CITY PLANNING COMMISSION
1231 "I" STREET, SUITE 200, SACRAMENTO, CA 95814

- APPLICATION:**
- A. Negative Declaration
 - B. Rezone 1.23± partially developed acres from Standard Single Family (R-1) to Single Family Alternative (R-1A).
 - C. Tentative Map to subdivide one partially developed parcel consisting of 1.23± acres into eight vacant parcels.
 - D. Special Permit to construct 8 single family residences in the Standard Single Family Alternative (R-1A) zone.

LOCATION: 4520 and 4530 Austin Avenue

APPLC. NO. P92-129

PLAN A

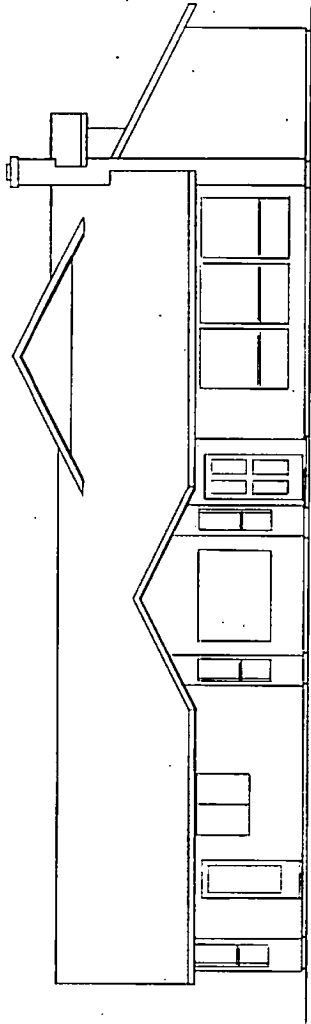
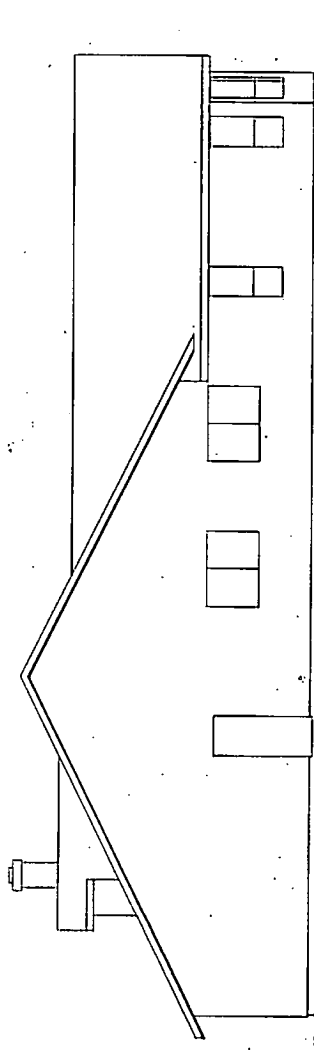
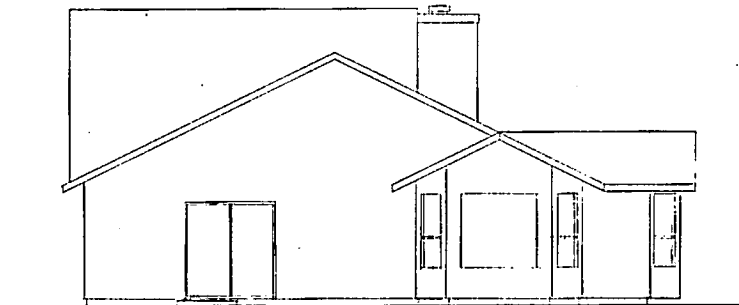
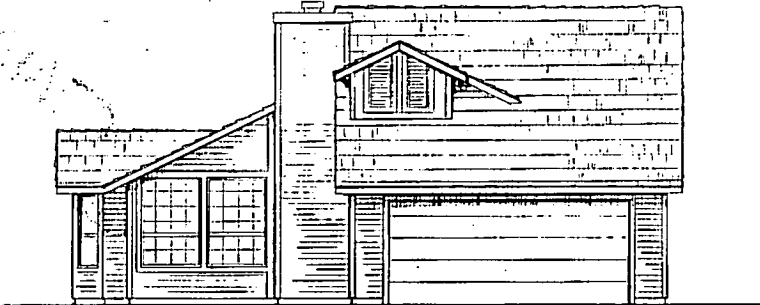
Plan A puts the front entry a long way back from the street. Hidden entries invite break-ins.

1. The applicant shall redesign three plans to place more living space to the front of the buildings and be approved by the design review staff prior to issuance of a building permit.

Plan B.

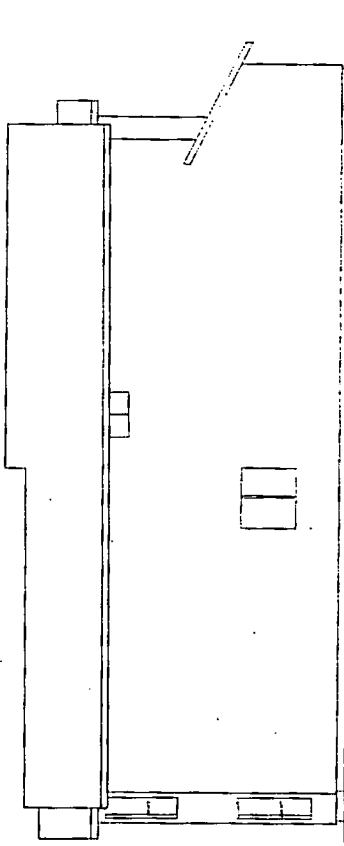
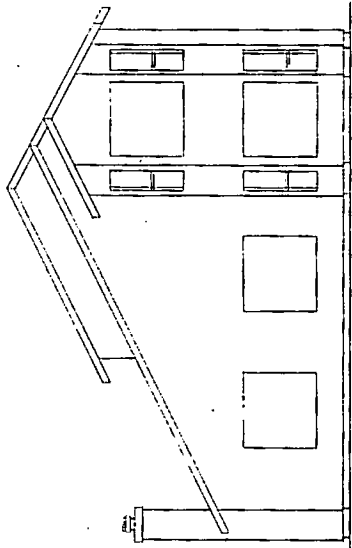
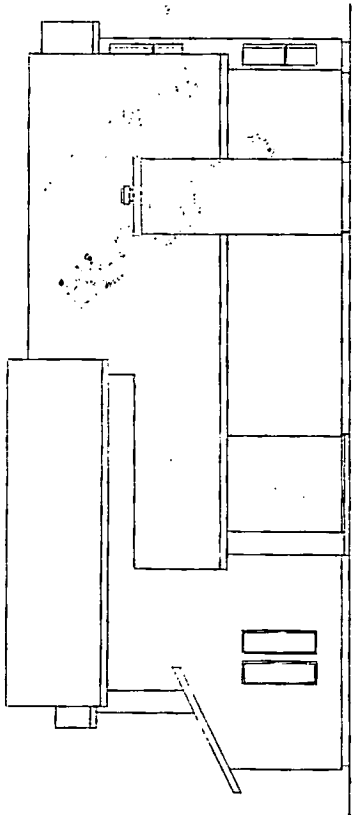
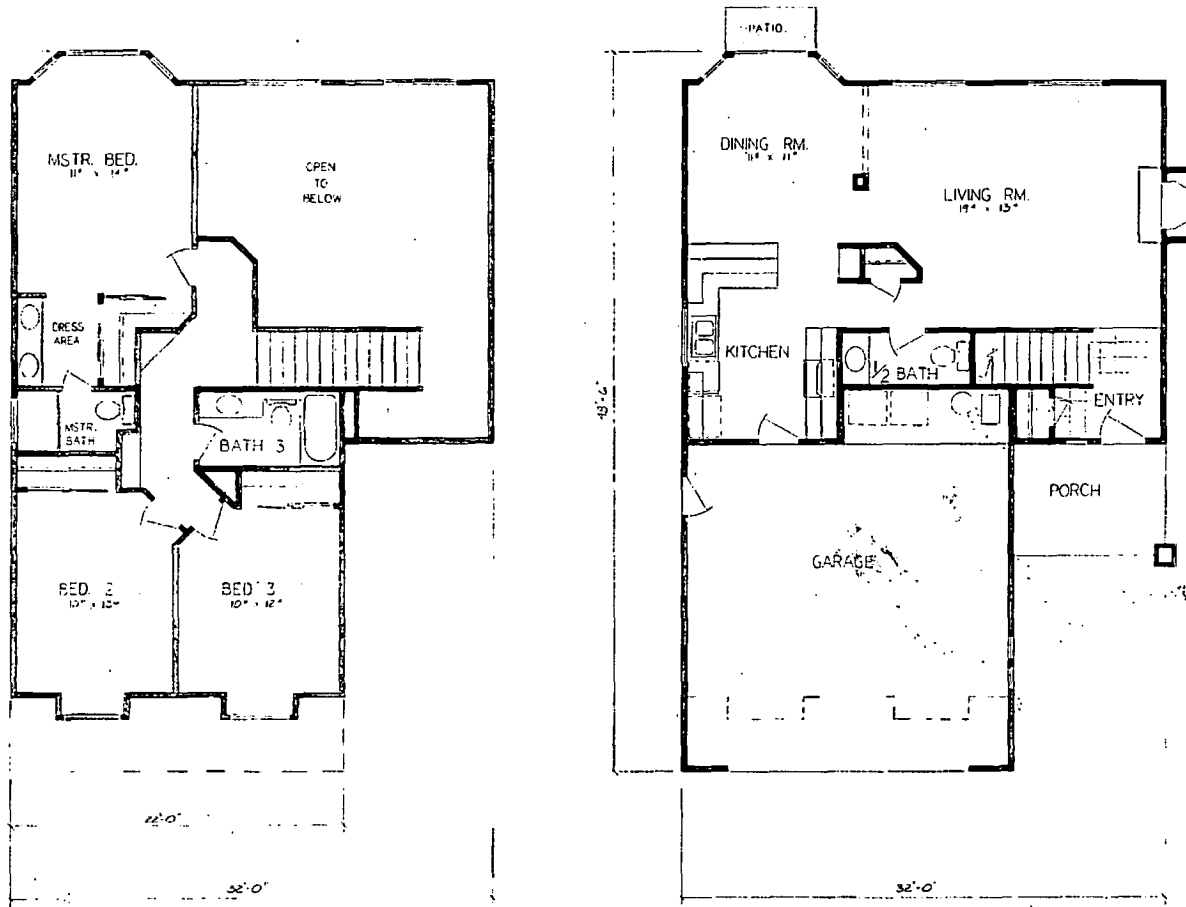
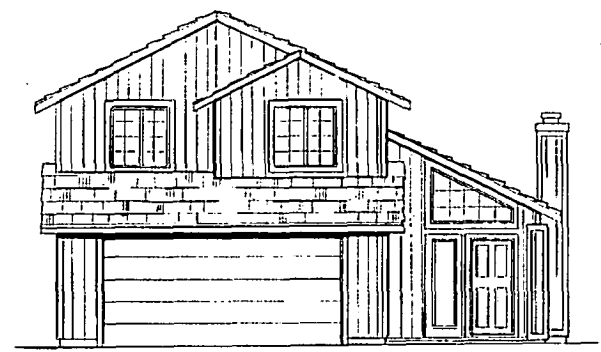
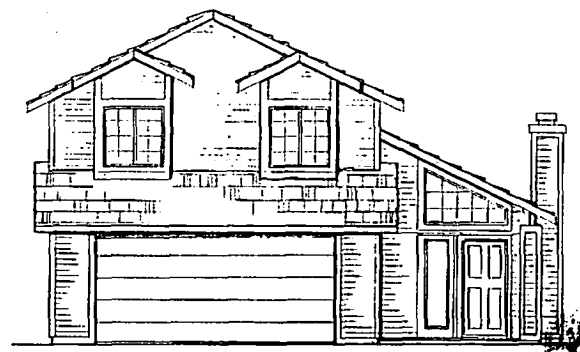
There should be a redesign of Plan B to place more living space to the front in order to allow more natural observation of outside activity (street, neighbors, etc.) from the first floor.
